**ADDENDUM 2 TO THE
FINAL DRAINAGE REPORT
FOR
HOMESTEAD AT STERLING RANCH FILING NO. 2

EPCD File No. SF-19-004/CDR-20-012
PCD File No. VR234**

**April 17, 2023
Project No. 25188.29**

**Prepared By:
JR Engineering, LLC
5475 Tech Center Drive, Suite 235
Colorado Springs, CO 80919
719-593-2593**

Basin ID: Sand Filter - Basin X1 - Existing

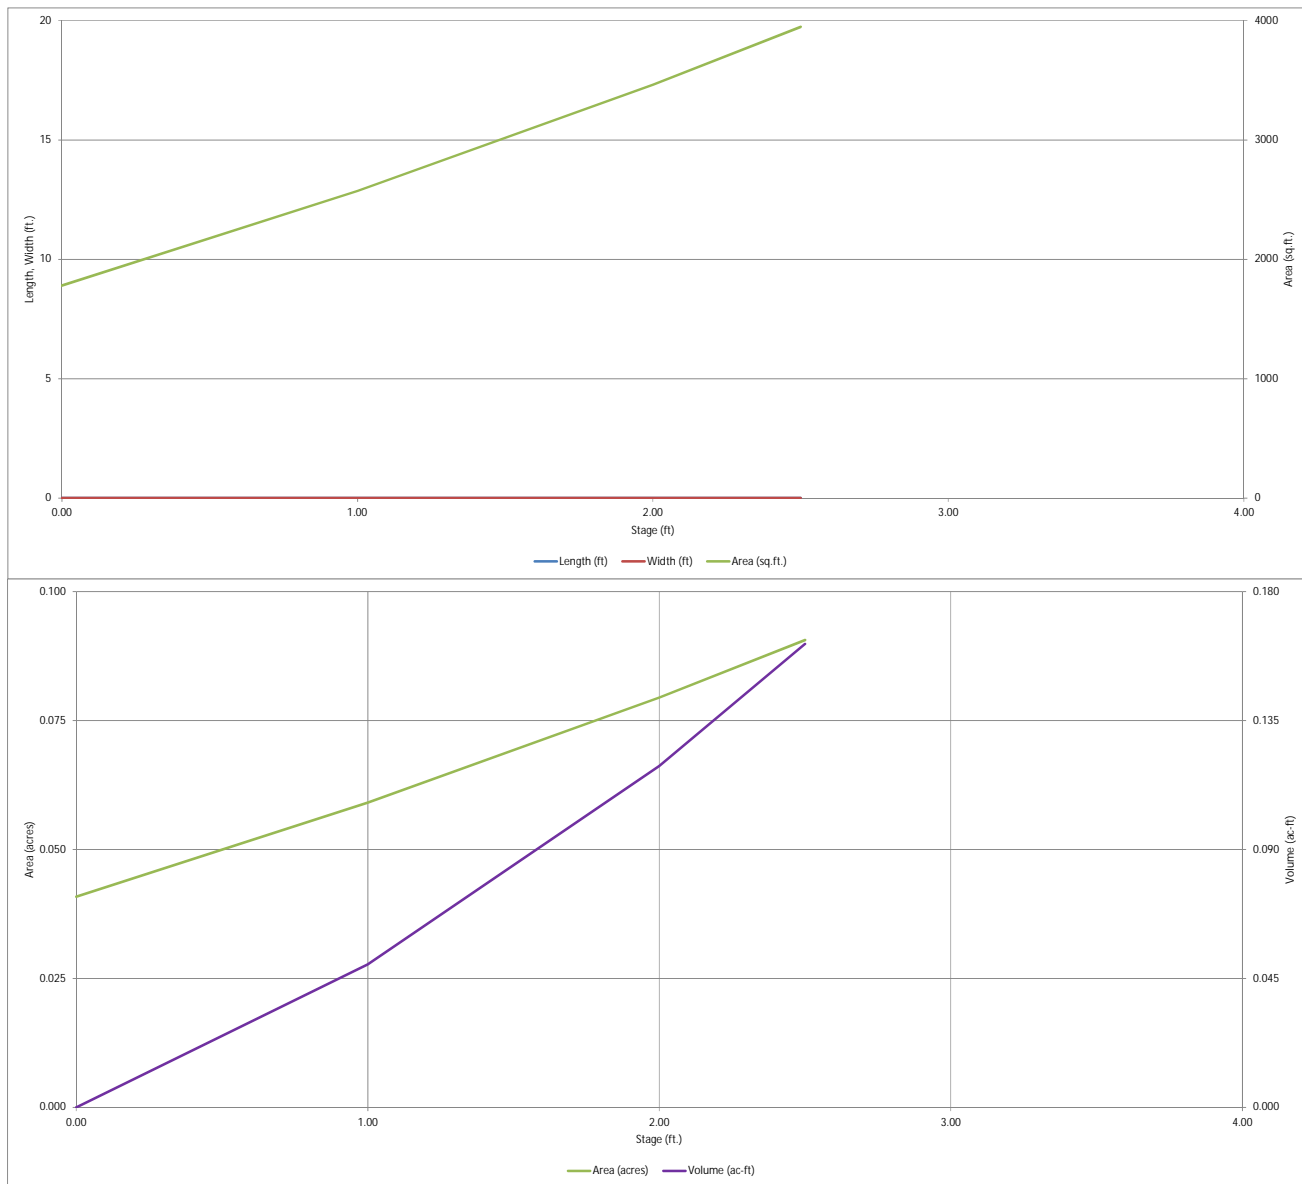
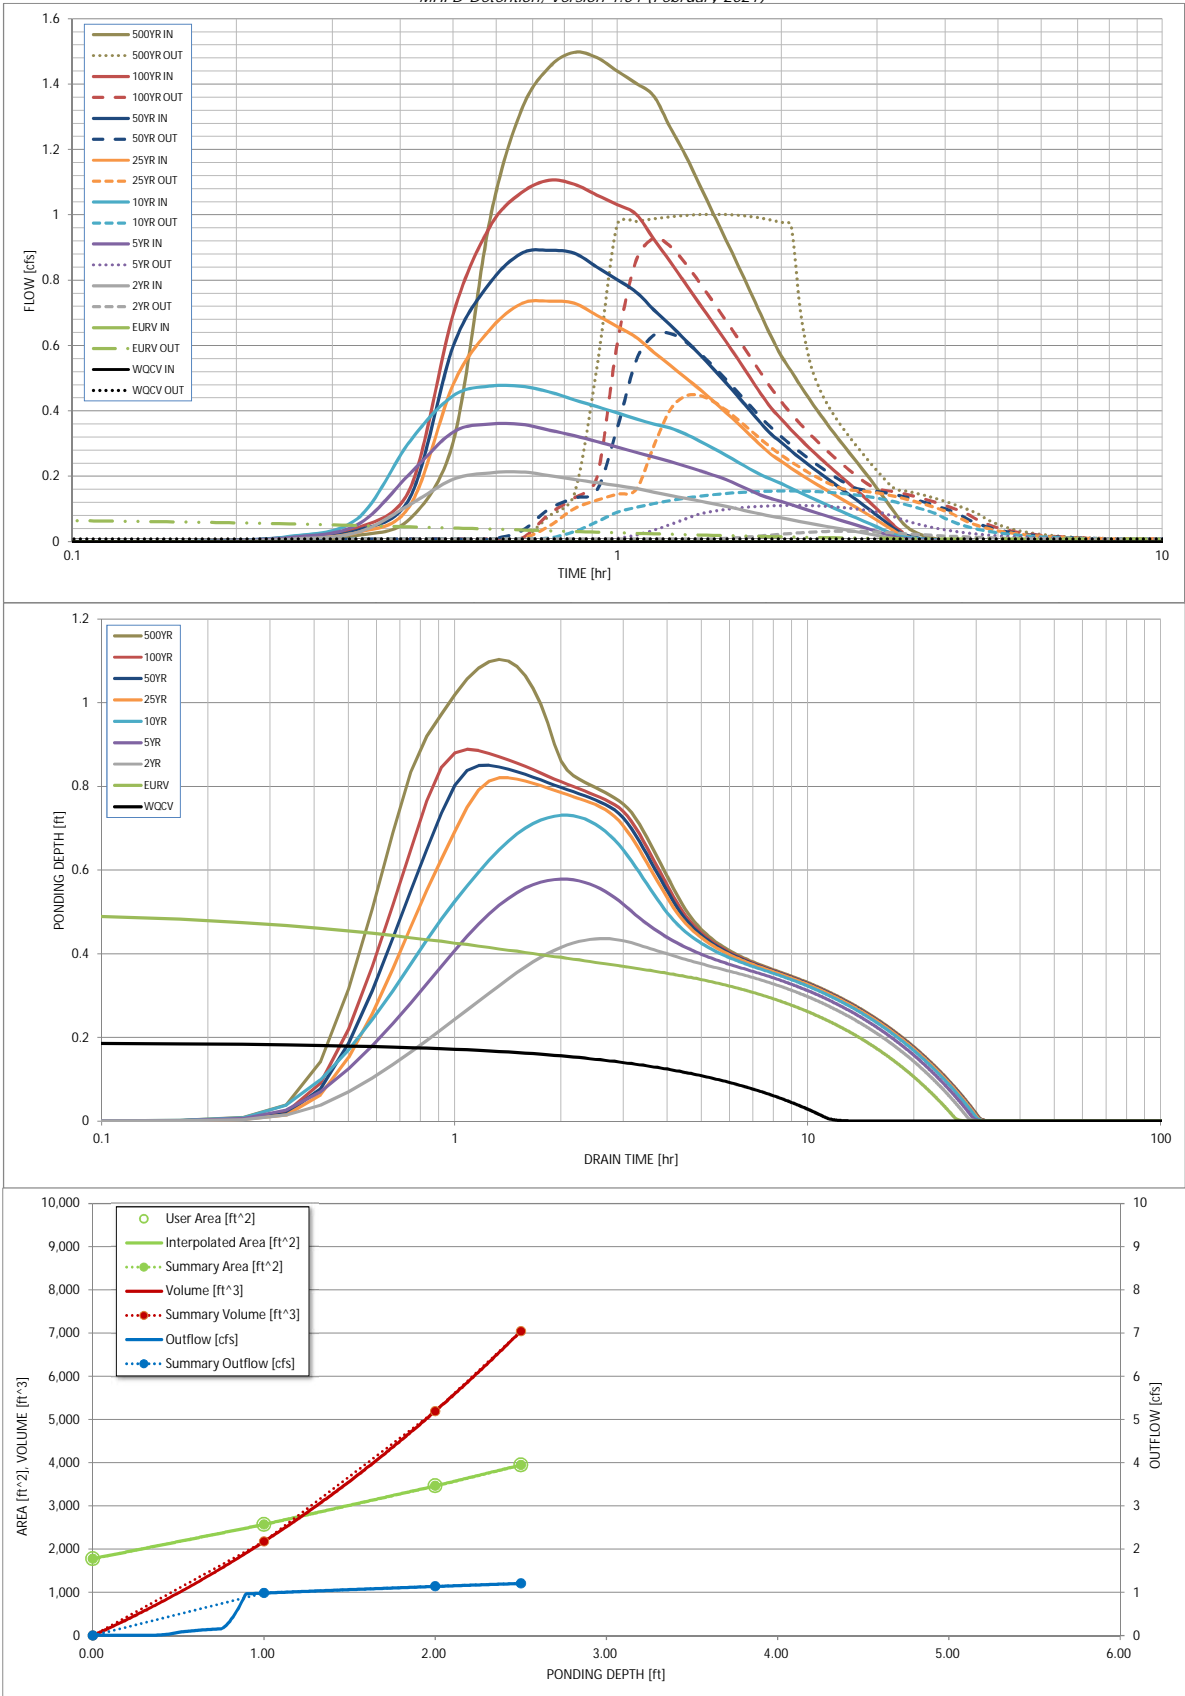
The design of the full-spectrum Sand Filter 1 (North Sand Filter) outlet structure changed to accept the additional area of the new proposed lot 2 within Basin X1. Italicized text within this section is original and unchanged. Runoff from this additional lot will be collected in a drain basin and piped via a private storm sewer into the Sand Filter 1. The new proposed flared end section (FES) in the sand filter will be protected by Type L riprap per the previously approved design. The runoff will be treated in the full-spectrum sand filter, and discharged into Sand Creek via an existing private storm sewer system. The increased Basin X1 area from 0.78 acres to 0.91 acres (as shown in the Detailed Drainage Discussion section) caused changes to the outlet structure in order to meet the required drain times. Specifically, the underdrain orifice diameter increased from 0.42 inches to 0.46 inches and the height of the restrictor plate above the outlet pipe invert increased from 1.90 inches to 2.50 inches. *Sand Filter 1 was designed to have a 12 hour WQCV drain time and a peak outflow for the 100 year design storm of 0.9 cfs which is less than or equal to pre-development peak flows. The peak discharge rate of the proposed sand filter is at or below the historic flows for the basin which it serves.* See the comparison table at the end of the Water Quality Provisions section to see the changes to Sand Filter 1.

| Addendum to the Final Drainage Report for Homestead at Sterling Ranch Filing No. 2 | | | | | | | |
|--|------------------------|-----------------------|-----------------------|----------------------------------|---------------------------|---------------------------|--------------------------------------|
| Sand Filter 1 | 0.91 | 0.008 | 0.015 | 0.031 | 0.008 | 0.023 | 0.043 |

PROPOSED DRAINAGE MAP
(ADDENDUM)
HOMESTEAD AT STERLING RANCH FILING NO. 2
JOB NO. 25188.29
04/17/2023
SHEET 1 OF 1

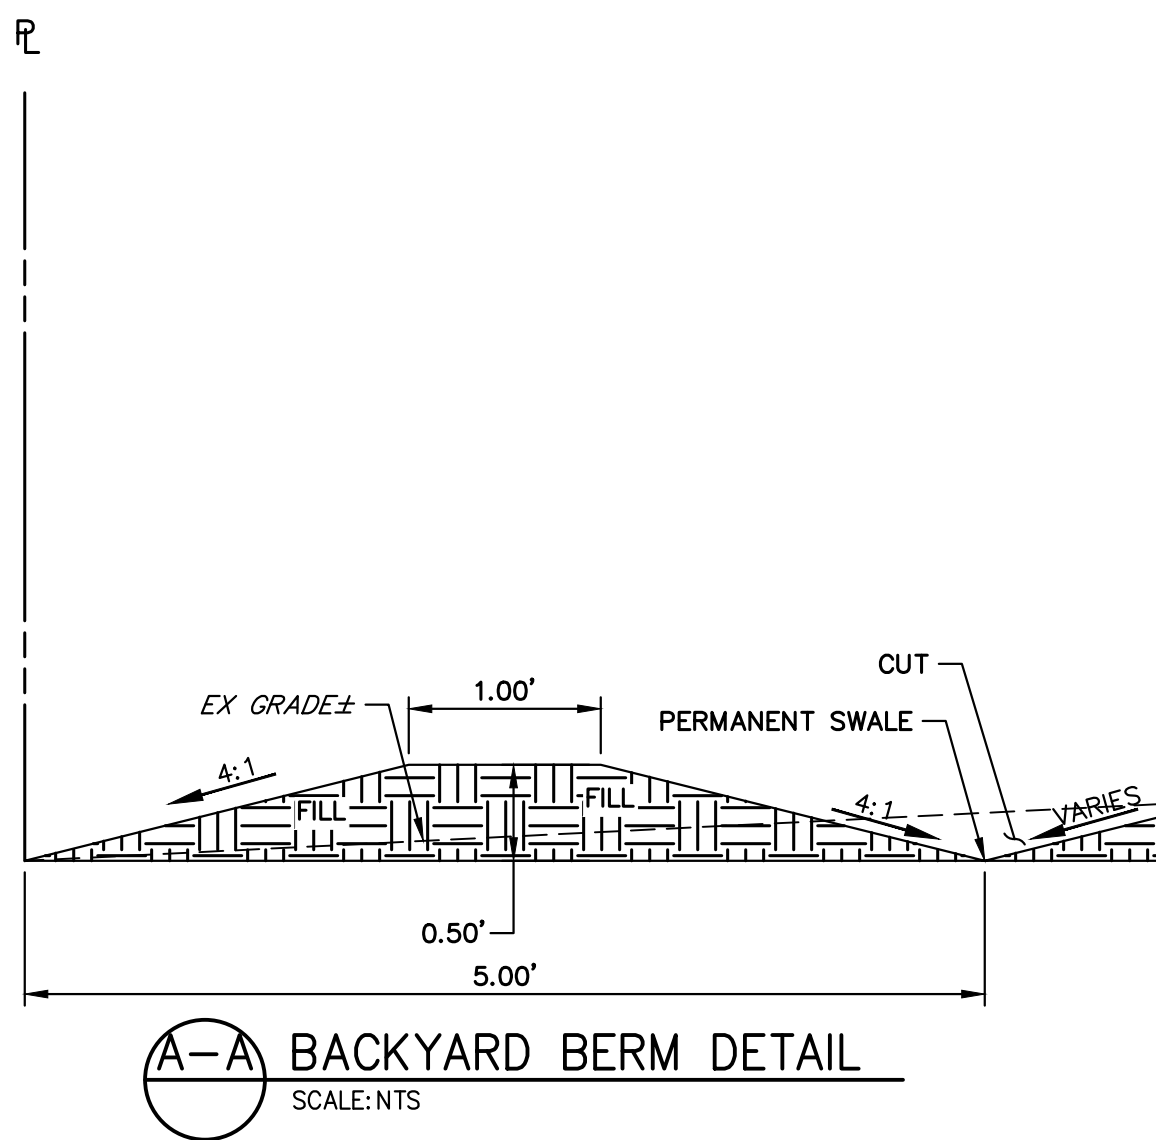
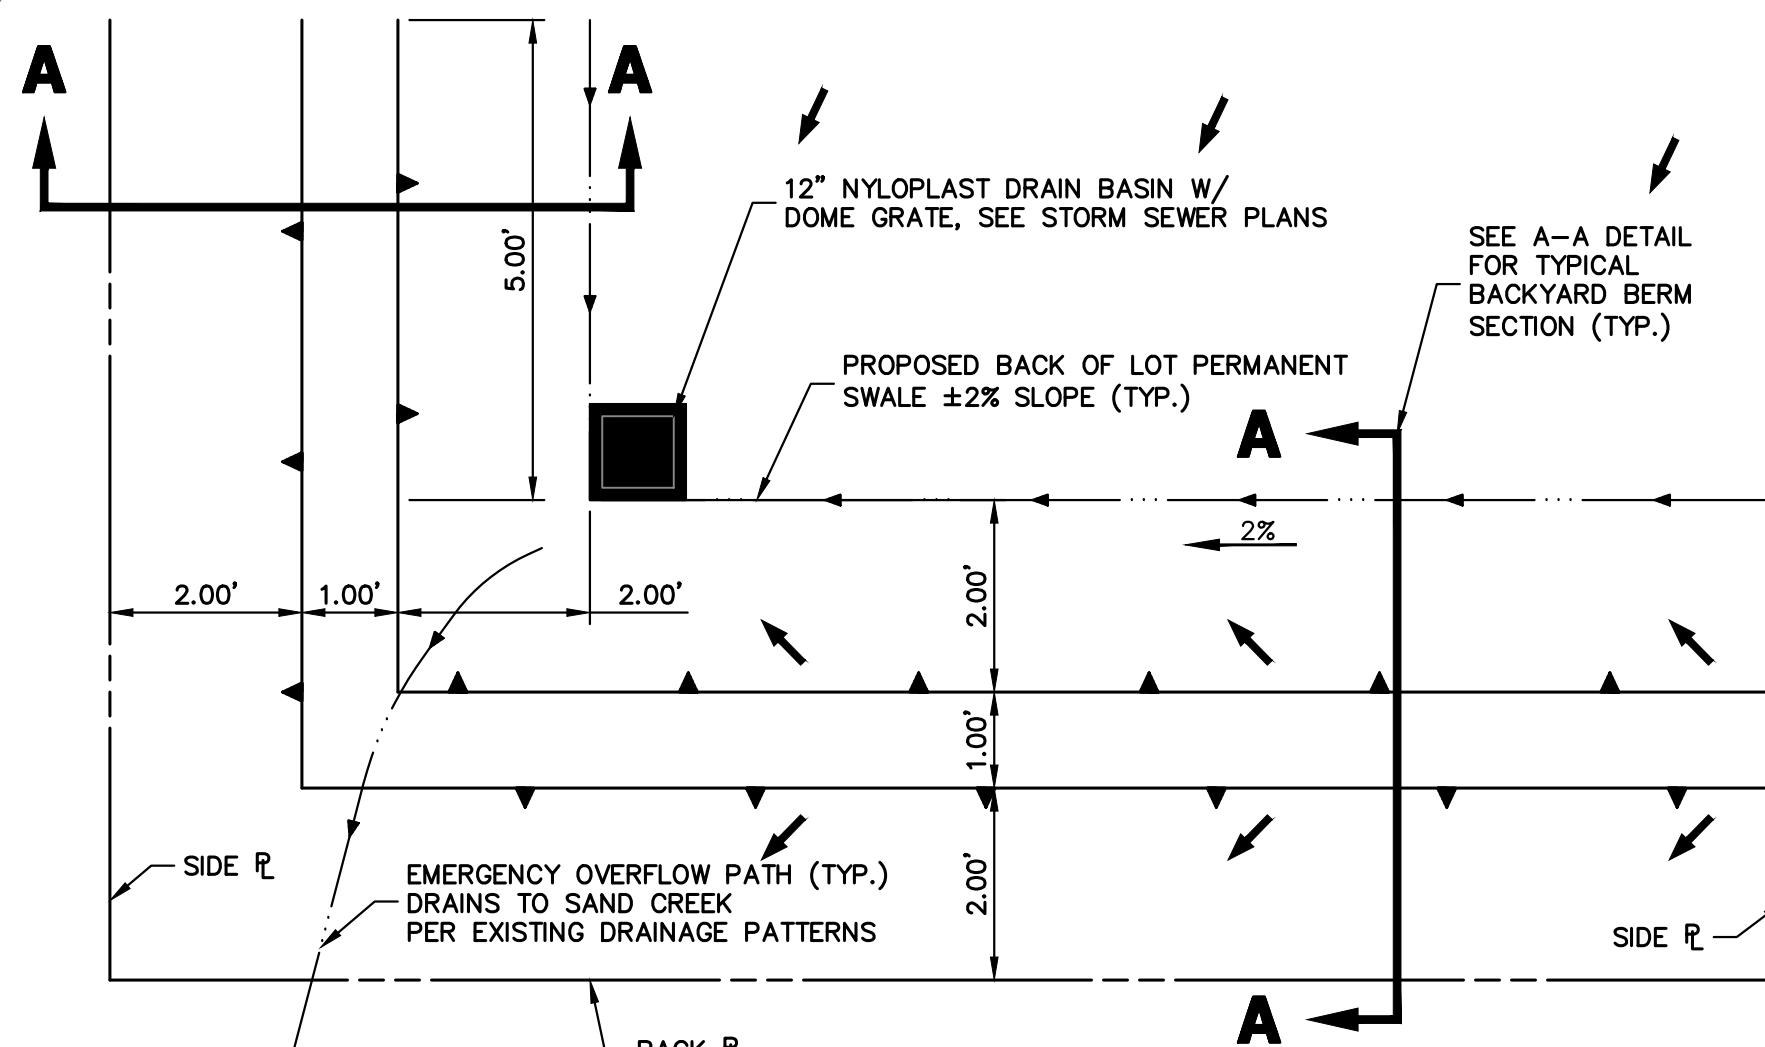
BASIN X1 (0.91 acres), consists of existing residential backyards of lots 36-41 and proposed new lot along the eastern boundary of the site. Italicized text within this section is original and unchanged. Basin X1 increased in size due to the additional lot 2 that will be treated within existing Sand Filter 1. Previously the area for the new lot was located within a tract and was assumed to drain freely to the existing Sand Creek. In accordance with the previous design, a swale/berm and area drain will be used for the new lot to collect the runoff and pipe it directly to existing Sand Filter 1. *Runoff in this basin will be directed via backyard swales/berms towards the rear of the lots where it will be collected in a 12” Nyoplast Drain Basin w/ a 12” dome grate placed in the rear southwest corner of each lot. Each lot will have a half foot berm/swale along the rear and low side of lot that directs water to each inlet, see the detail included on the drainage map, GESC, and Storm plans. Should the inlet in any lot become clogged, the berm will overtop, and flow will continue to Sand Creek. Per the original drainage report by MandS, the estimated flows per each lot in basin X1 = 0.2 cfs for the 100 year storm. The 12” Nyoplast Drain Basins are sized to collect all flows ($Q_5 = 0.7$ cfs, $Q_{100} = 2.6$ cfs) in both the 5 and 100 year storms. Collected flows will then be piped to a proposed full-spectrum sand filter, with a 12-hour drain time and a 4” perforated underdrain. The treated flows from the sand filter will be discharged via an outlet structure to the adjacent Sand Creek. See the comparison table at the end of the Detailed Drainage Discussion section to see the changes to Basin X1.*

BASIN W1 (0.84 acres), consists of existing residential backyards of lots 19-23 and a proposed adjustment to lot 24 (new lot 1) along the southeastern boundary of the site. Italicized text within this section is original and unchanged. Basin W1 decreased in size due to the adjustment to lot 24 decreasing the lot area. Only the runoff from lot areas are collected and treated in existing Sand Filter 2 and since the lot size is decreasing, the swale/berm configuration along the back of the lot is also decreasing in length. *Runoff in this basin will be directed via backyard swales towards the rear of the lots where it will be collected in a 12" Nyoplast Drain Basin w/ a 12" dome grate placed in the rear corner of each lot (DP3). Each lot will have a half foot berm/swale along the rear and low side of lot that directs water to each inlet, see the detail included on the drainage map, GESC, and Storm plans. Should the inlet in any lot become clogged, the berm will overtop, and flow will continue to Sand Creek per existing drainage patterns. The 12" Nyoplast Drain Basins are sized to collect all flows ($Q_5 = 0.6$ cfs, $Q_{100} = 2.2$ cfs) in both the 5 and 100 year storms. Collected flows will then be piped southwest via 12" HDPE pipe following the rear lot lines towards DP3.1, where flows in the pipe combine with collected flows from Basin X2 ($Q_5 = 1.3$ cfs, $Q_{100} = 4.6$ cfs). See the comparison table at the end of the Detailed Drainage Discussion section to see the changes to Basin W1.*
